**Reservoirs Act 1975  
2021 Annual Supervising  
Engineer's Statement under  
Section 12(2) and Section  
12(2A)**

Poynton Lake

11 November 2021

Cheshire East Council  
Municipal Buildings  
Earle Street  
Crewe  
Cheshire  
CW1 2BJ

## **C. Proposed works to enable safe overtopping**

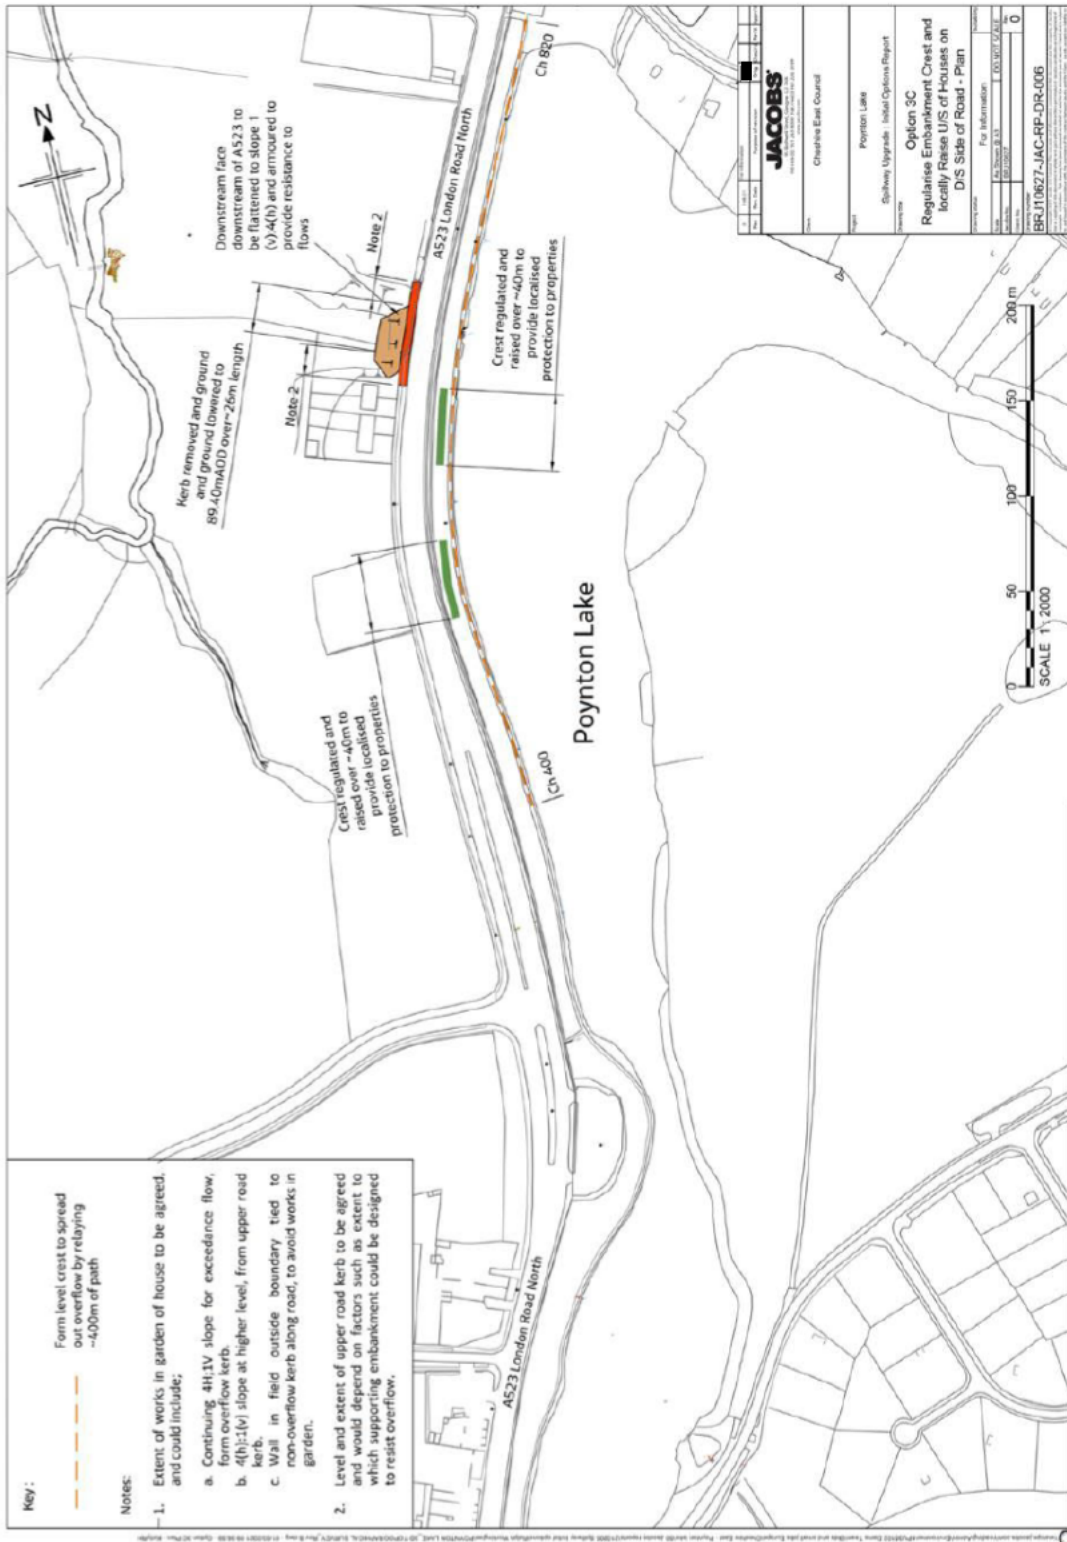
The council has received options on how to provide a 400m section of over-toppable embankment by the construction of low level walls. It is planned that significant tree clearance along the front face will be undertaken during January and February 2022, with the civil works undertaken during September to November 2022. An outline arrangement has been provided in Appendix C.

As part of the proposed works, the 400m section of over-toppable embankment is to have all the trees along its upstream face removed. It is suggested that reeds be allowed to establish along this section to provide protection to the face of the dam.

It is obvious from the water level compared to the path that the embankment does not have an even elevation. This will be addressed as part of the proposed works to enable safe over-topping.

The alignment of the 400m length of over-toppable embankment corresponds to where the downstream face is sloped and not retained by a masonry wall (Photo 9). **It is recommended that where the downstream slope is not retained by a masonry wall, then the face is regularly cut to encourage grass growth.**
